Access Compliance Report

Public Rights-of-Way

(Curb Ramps)

Intersection ID: 12618	Main Street: E_5TH_ST	Cross Street: N_CALDWELL_ST	Location: S
ADA ID: 612AE55DD7CD	Ramp Type: Perp	Initial Pass/Fail: Fail	Overall Compliance: No
Severity Score: 10			
Codes/Mitigation Info/Possible Solution		Field Measurements/Component Compliance

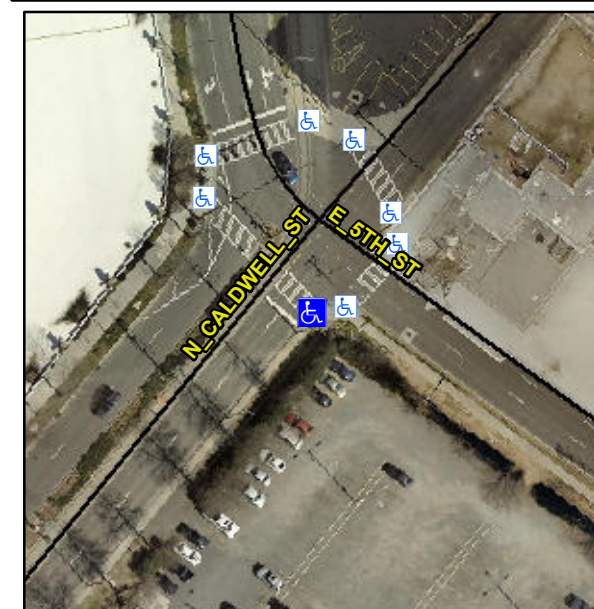
Not Found, R304.5.1, R304.5.3

Compliance	Description	Data	Compliance	Description	Data
N/A	Ramp Length (in)	73.0	Yes	Ramp Slope (%)	6.3
No	Ramp Width (in)	38.0	No	Ramp XSlope (%)	2.7
N/A	Flare Type LT	N/A	N/A	Flare Type RT	N/A
N/A	Flare Slope LT (%)	N/A	N/A	Flare Slope RT (%)	N/A
N/A	Flare Traversable LT?	N/A	N/A	Flare Traversable RT?	N/A
N/A	Landing Length (in)	N/A	N/A	DWS Provided?	N/A
N/A	Landing Width (in)	N/A	N/A	DWS Contrast?	N/A
N/A	Landing Slope (%)	N/A	N/A	DWS Length (in)	N/A
N/A	Landing X Slope (%)	N/A	N/A	DWS Full Width?	N/A
N/A	Landing Curb? (Y/N)	N/A	N/A	DWS Offset (in)	N/A
N/A	Shared Landing?	N/A			
N/A	Gutter Ponding?	N/A	N/A	Gutter Slope (%)	N/A
N/A	Gutter Lip Ht (in)	N/A	N/A	Gutter X Slope (%)	N/A
N/A	Painted X Walk1?	Yes	N/A	Painted X Walk2?	N/A
	X Walk 1 Direction	To NW		X Walk 2 Direction	N/A
N/A	X Walk 1 Width (in)	113.0	N/A	X Walk 2 Width (in)	N/A
	X Walk 1 Slope (%)	7.4		X Walk 2 Slope (%)	N/A
	X Walk 1 X Slope (%)	1.8		X Walk 2 X Slope (%)	N/A

Remove & Replace Entire Ramp.
